**Bent Grass Residential Filing No. 2**  
**Traffic Impact Study**  
PCD File No.: SF-1914  
(LSC #194460)  
January 24, 2020

# Summary of Comments on Working File - LSC Responses to County TIS Redline Comments 3-13-20.pdf

SUBJECT: SF-19-014– Bent Grass Residential Filing No. 2  
Third Submittal  
**(w/ LSC Responses – 4/19/2020)**

Figure 10  
**Year 2040 Total Traffic, Lane Geometry, Traffic Control and Level of Service**  
 Bent Grass Residential Filing No 2 (LSC #194460)

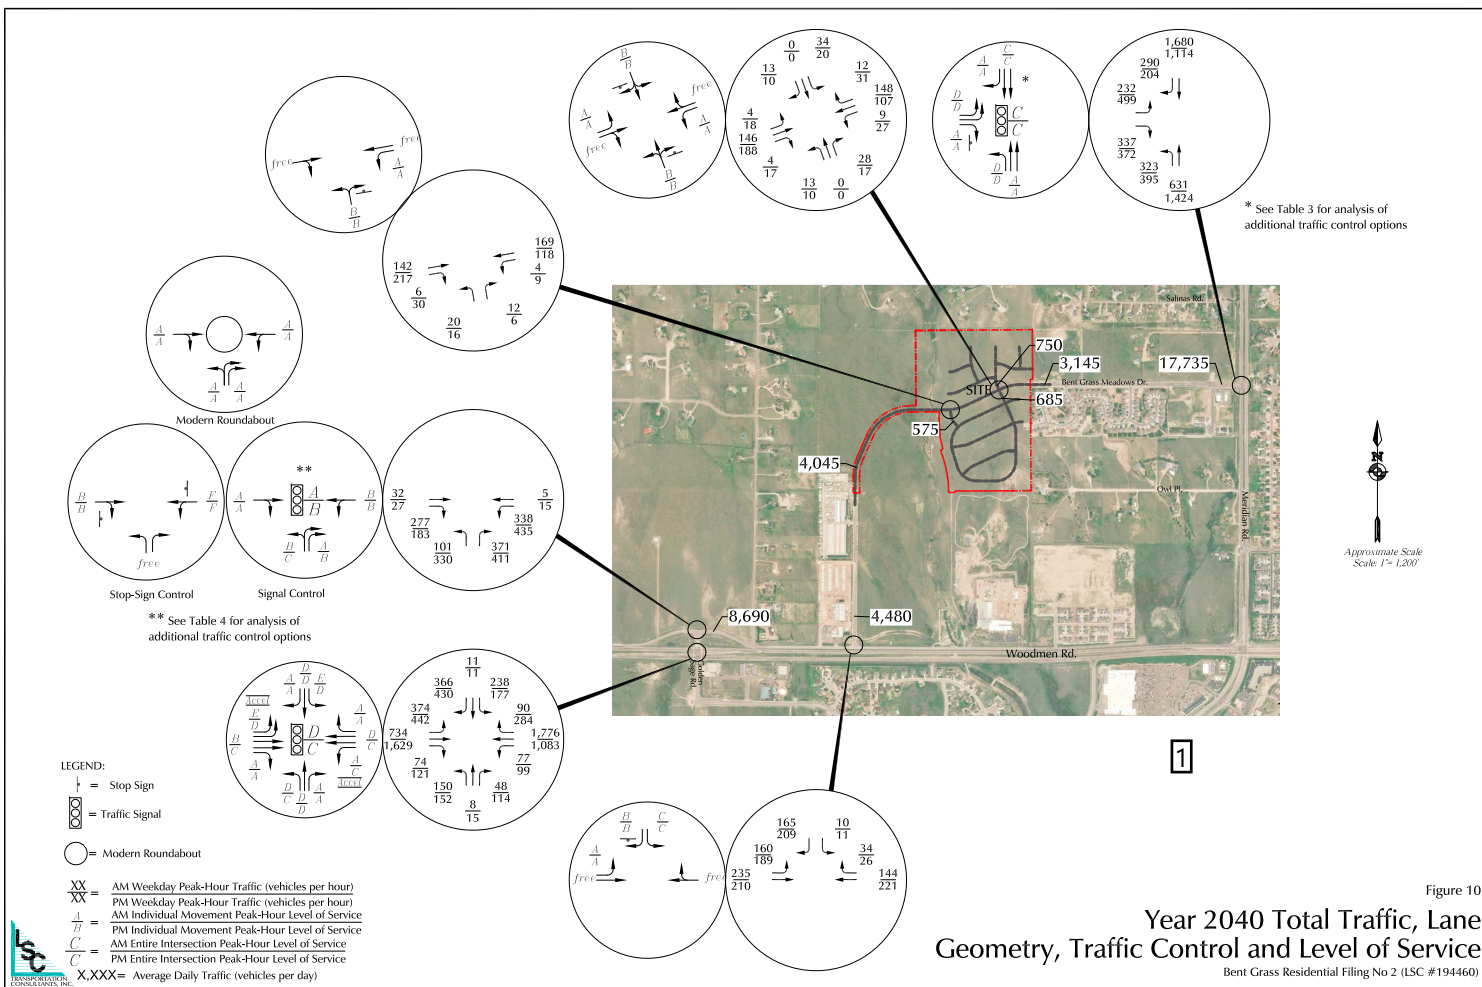
Add a note addressing this potential access. (Would westbound traffic be likely to use this to access Bent Grass Meadows Drive?)

LSC Response: This has been added to the TIS as requested.
